Bidding Addendum

Addendum No. 1

Issue Date:	October 14, 2026	**CPL Project No:**	R25.19314.00
Client:	Lakeland Community College	**Client Project No:**	TK26SEP30
Project:	“Breakers” Food Service Renovation		
From:	CPL Architects, Engineers, Landscape Architect D.P.C. 25 Main Street, Suite 200 Westlake, Ohio 44145	**Contact:**	Kiernan Weese kweese@cplteam.com
Distribution To:	All Pre-Bid Attendees Lakeland Community College Tec Inc. TriMark USA	**Contact:**	N/A

CNH SERIES
CRISPY FOOD STATIONS

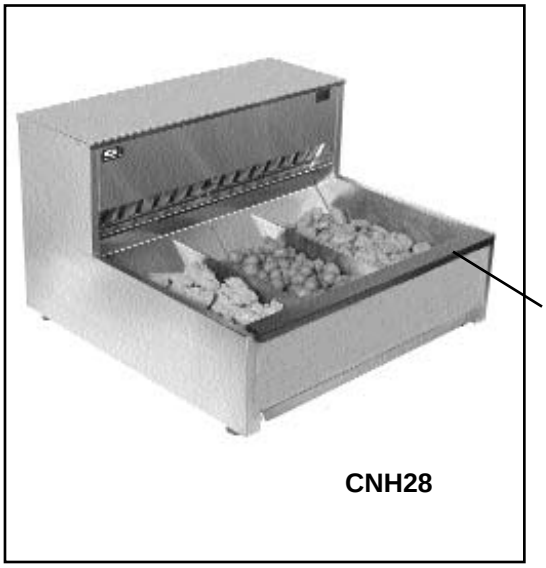
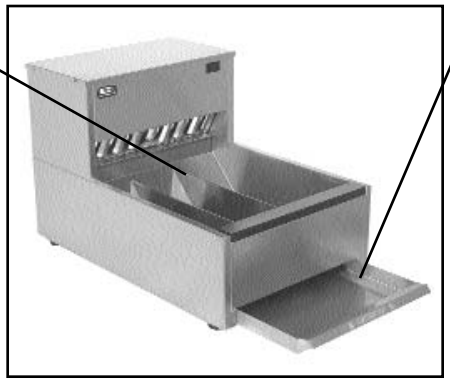
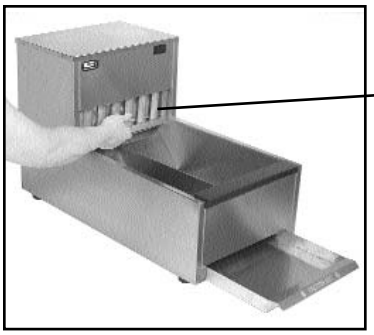
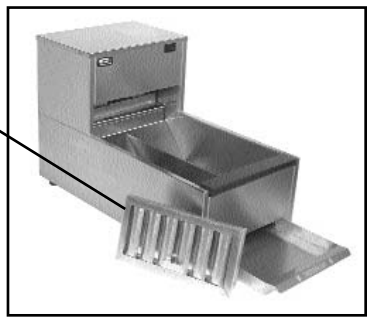
RFI 7.1 Written specifications call for 208/1 for basis of design Carter Hoffman however the specified unit is not available in that voltage. Please confirm if "120v/60/1-ph, 1820 watts, 15.1 amps, NEMA 5-20P standard " is acceptable or if 240/60/1-ph upcharge needs to be included.

Answer *The specified Carter-Hoffmann CNH28 is available in the 208V/60Hz/1-phase configuration, as confirmed by the manufacturer's product data included in this Addendum. Provide the specified 208V, 2,890-watt, 14-amp unit with NEMA 6-20P plug. No substitution or voltage modification is required.*

Issued: 9/28/2026
Scale: As indicated
Project Status: BID AND PERMIT
Drawn By: CPL
Checked By: CPL
Drawing Title: LEVEL 1 DEMOLITION PLAN - OVERALL
Drawing Number: A101

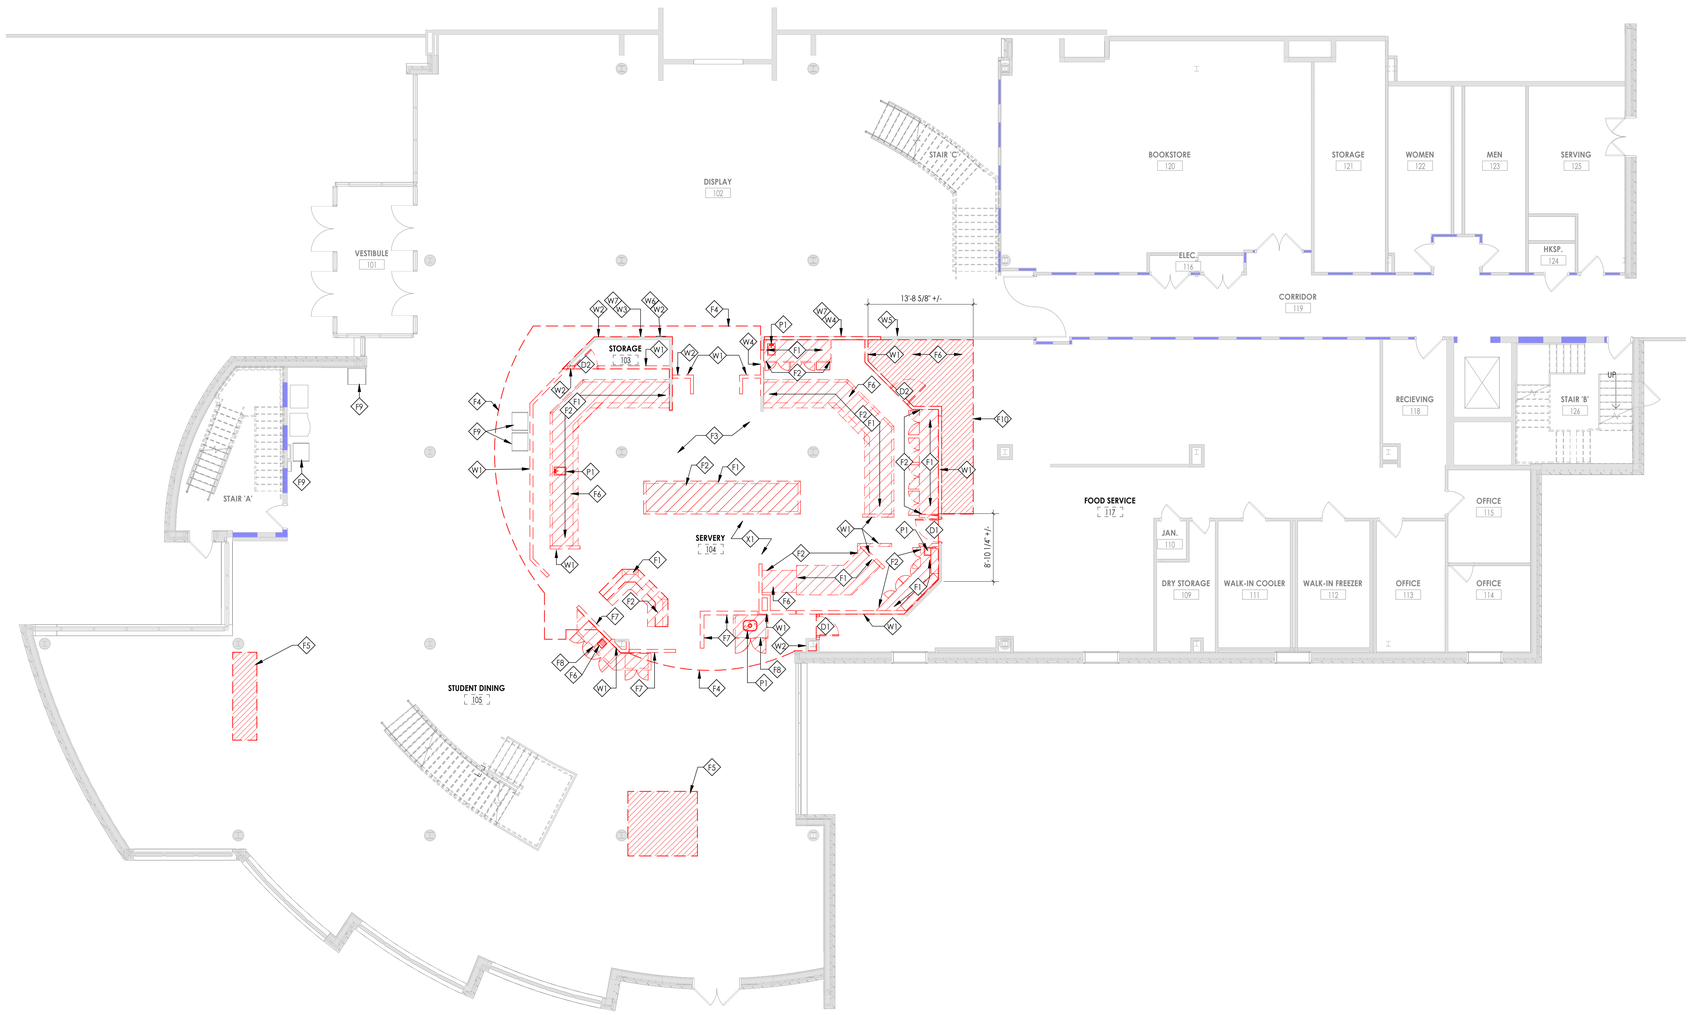
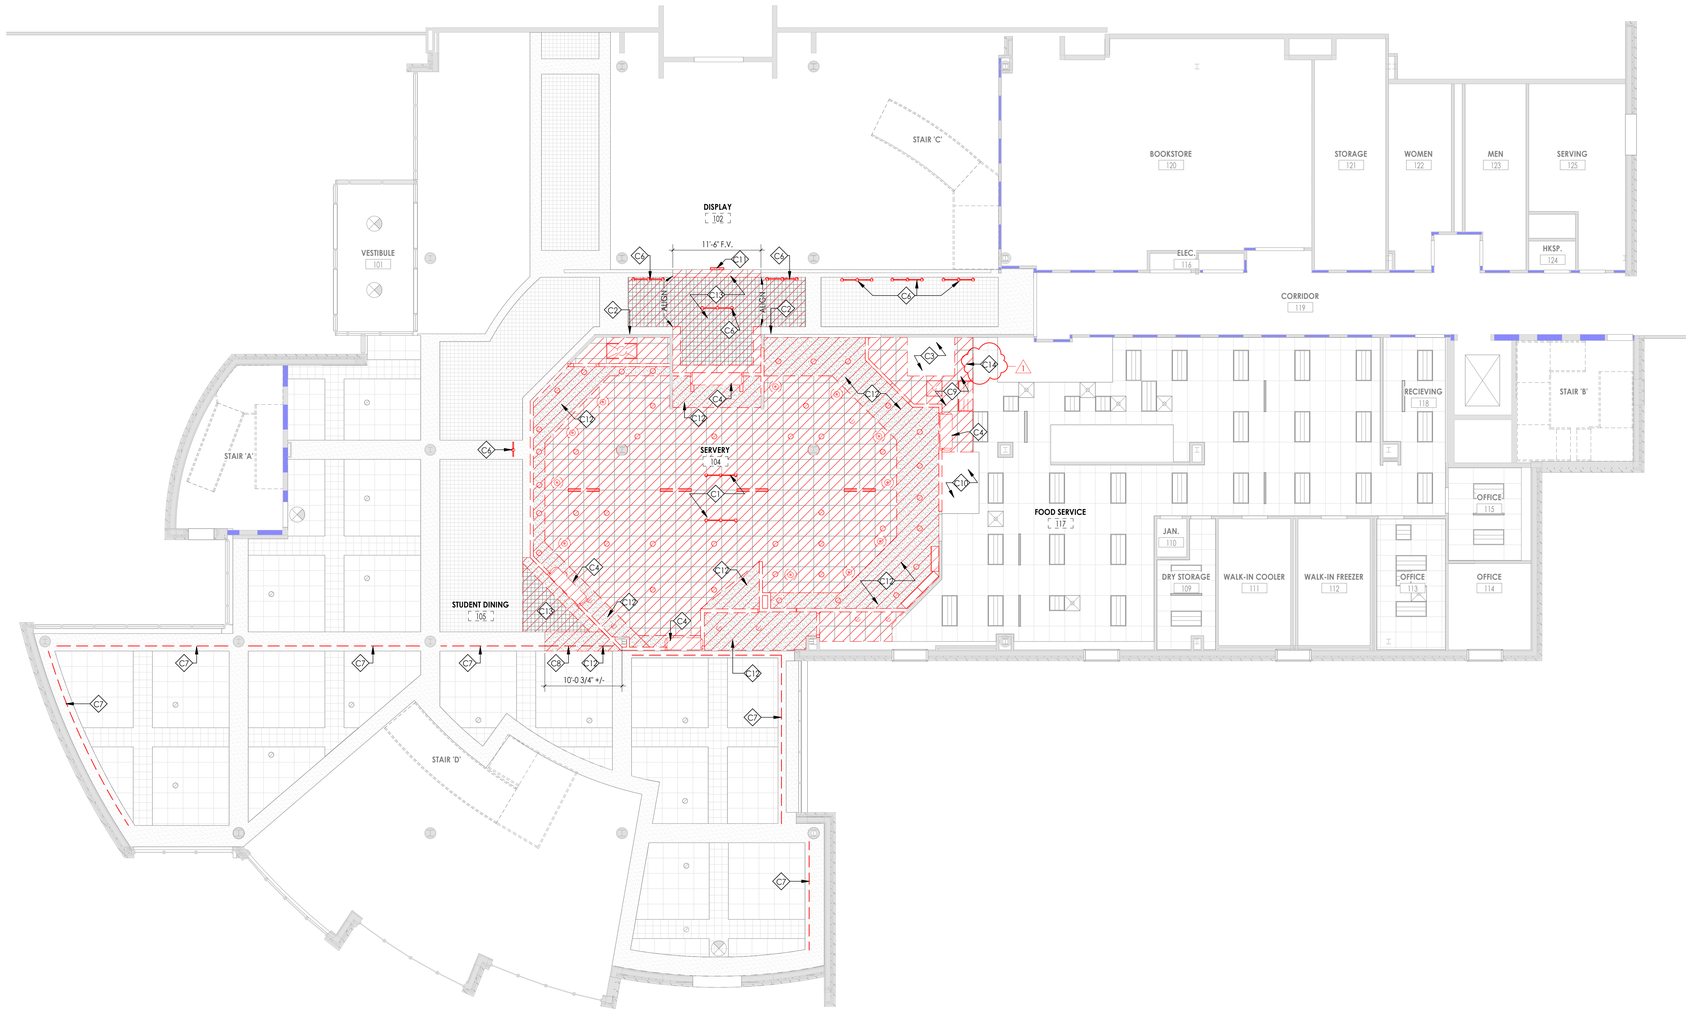
RFI 3 Drawing A101 note F10 calls to remove the existing quarry tile and setting material and for new flooring to match the adjacent flooring. Note F4 only calls for terrazzo to be ground to allow for a smooth transition to sheet vinyl to be laid overtop of the existing terrazzo which encapsulates this quarry tile area. If alternate #7 is not accepted and the sheet vinyl is decided against, will the quarry tile still need to be removed? If the tile is still intended to be removed what will the replacement flooring be?

Revised Demolition Keynote F10 to clarify the extent of existing quarry tile and base removal, substrate preparation requirements, and coordination with the Owner-contracted terrazzo flooring contractor.

Answer *Should Alternate #7 not be accepted, scope of work is to include removal of quarry tile, setting, material, and base, down to existing concrete substrate in the indicated area. GC is to coordinate demolition, substrate preparation requirements and scheduling with owner-contracted flooring contractor.*

- F8 REMOVE EXISTING MILLWORK.
- F9 SALVAGE ROLLING TRASH RECEPTACLES. STORE FOR RELOCATION. COORDINATE WITH OWNER.
- F10 REMOVE EXISTING QUARRY TILE FLOORING, SETTING MATERIAL, AND BASE DOWN TO EXISTING CONCRETE SUBSTRATE. PREPARE EXISTING SUBSTRATE AS REQUIRED TO RECEIVE NEW FLOORING AT THE REQUIRED FINISHED FLOOR ELEVATION. PROTECT ADJACENT EXISTING TERRAZZO FLOORING TO REMAIN. COORDINATE DEMOLITION, SUBSTRATE PREPARATION REQUIREMENTS, AND SCHEDULING WITH OWNER CONTRACTED TERRAZZO FLOORING CONTRACTOR.

Drawing Number: A102

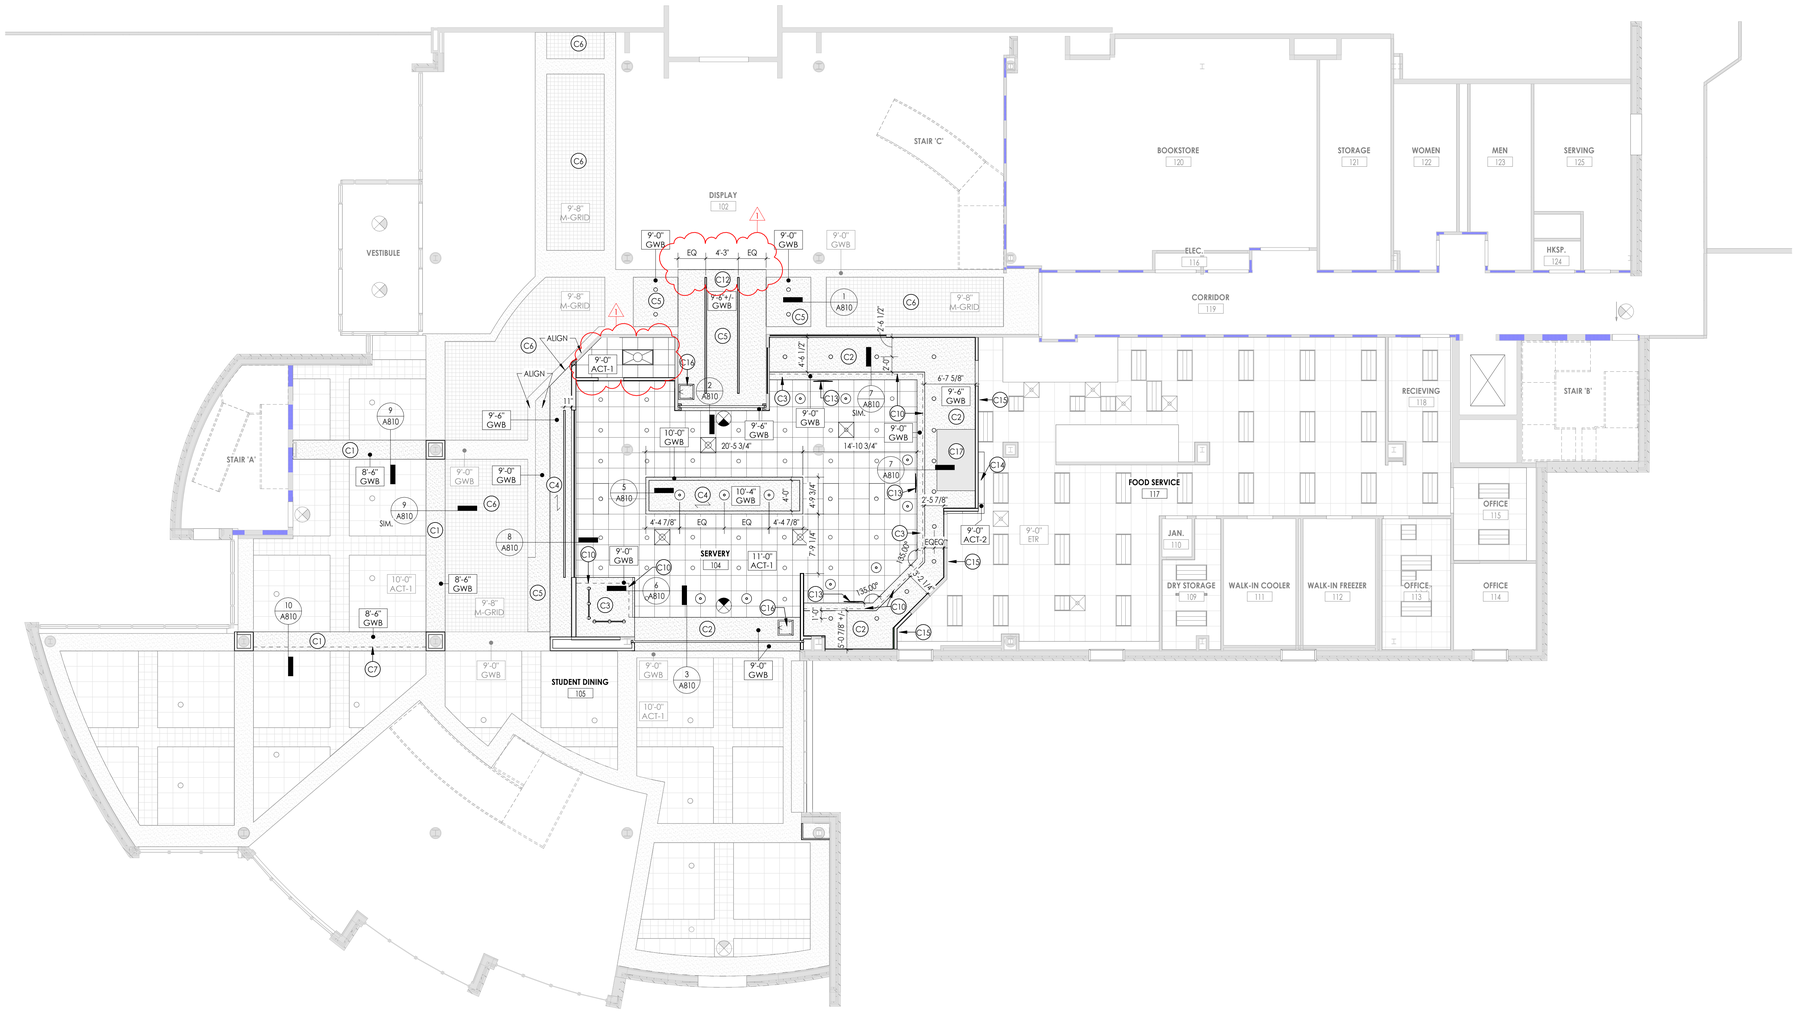
Added Demolition Keynote C14 to clarify removal and salvage of existing ceiling tiles and grid for reuse and modification.

- C14 REMOVE EXISTING CEILING TILE AND GRID. SALVAGE COMPONENTS AND TILE FOR REUSE AND TRUNCATION. REFER TO RCP.
- D1 REMOVE EXISTING DOOR, FRAME AND ASSOCIATED HARDWARE. PATCH AND REPAIR ADJACENT WALLS AND FINISHES AS REQUIRED TO MATCH EXISTING AND ACCOMMODATE NEW WORK.

Issued: 9/28/2026
Scale: As indicated
Project Status: BID AND PERMIT
Drawn By: CPL
Checked By: CPL
Drawing Title: LEVEL 1 REFLECTED CEILING PLAN - OVERALL
Drawing Number: A601

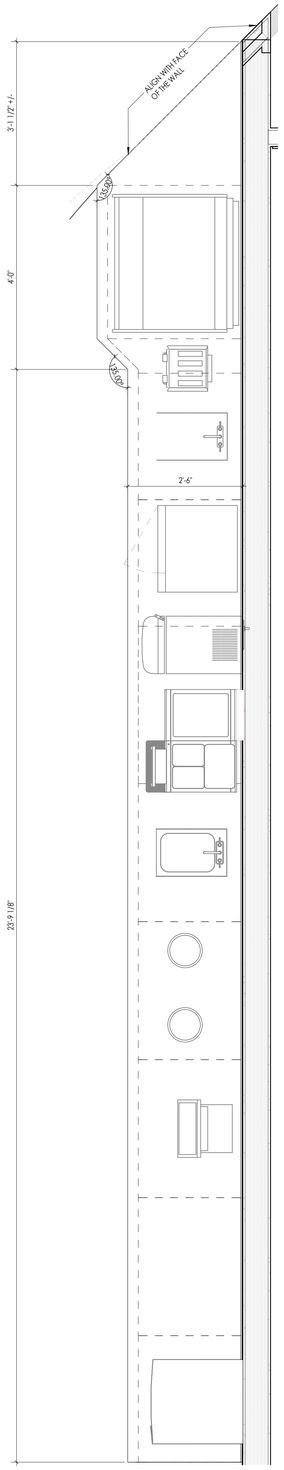
RFI 5 The reflected ceiling plan on drawing A601 calls for ACT-2 for ceiling patching in Food Service 117 and Storage 103. Upon inspection of the project specifications, only ACT-1 is called out. The same occurrence is on drawing I000 only calling out ACT-1. Additionally, the intended ceiling grid as described in the specifications is to be galvanized steel grid with a steel cap. Previous experience with this style of grid is shown to be quickly corrosive in a food service climate. The recommended ceiling grid to utilize for this project would be galvanized with an aluminum cap. Please clarify ACT-2 and the intended grid to be used.

A601	Level 1 Reflected Ceiling Plan – Overall
	Clarified the existing ACT-2 ceiling designation in Food Service 117, including reuse of salvaged ceiling tiles and grid. Revised ceiling designation in Storage 103 from ACT-2 to ACT-1 to indicate new acoustical ceiling construction.
A712	Servery Callouts and Details
	Revised millwork details to clarify wall finish requirements, referencing the elevations and finish plan for locations requiring paint or wall protection.
I000	Interiors General
	Revised the Interior Finish Schedule to clarify ACT-2 as the existing acoustical ceiling system, with components to be salvaged and reused as required.
I200	Level 1 Floor Finish Plan
	Revised Finish Keynote ID1 to clarify substrate preparation and the Owner-contracted terrazzo installation under the Base Bid, and floor leveling and SV-2 sheet vinyl installation under Alternate 7.
QF601	Foodservice Construction Detail

Answer *ACT-2 denotes the existing acoustical ceiling system in Food Service 117 and Storage 103. Patch existing ceilings to match adjacent construction using salvaged ceiling tiles and grid. ACT-1 applies to new acoustical ceiling installations as indicated in the Contract Documents. Section 09 51 00, Paragraph 2.03.B, has been revised to specify a hot-dipped galvanized steel suspension grid with an aluminum cap in lieu of the originally specified steel cap.*

Drawing Number
-
A712

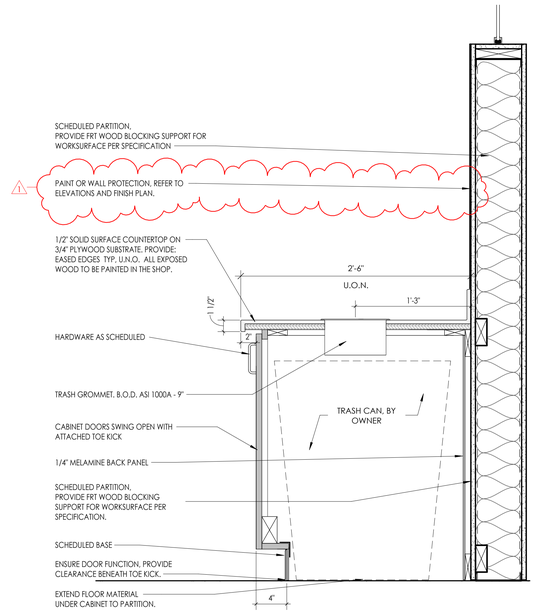
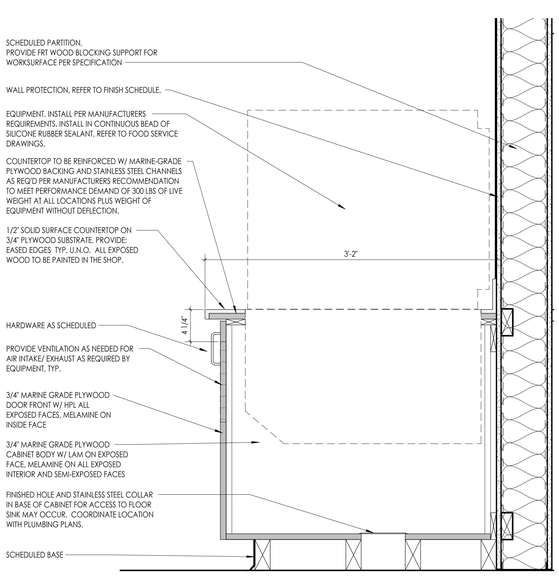
RFI 4 Drawing A711 identifies Alternate #1, Note "N31," as receiving a painted finish. However, Drawing A712, Sections 3 and 4, indicates that the same wall is to receive wall protection, as shown in the snippets below. Please clarify whether the intent of Alternate #1 is to provide a painted finish in lieu of wall protection. Additionally, please confirm whether the millwork located in the southeast corner is to be included as part of Alternate #1 or if this millwork is included in the Base Bid scope.

Answer *Wall finish beyond this section of millwork of Alternate #1 is to provide a painted finish. Wall protection is not desired for this location. Refer to addendum drawings.*
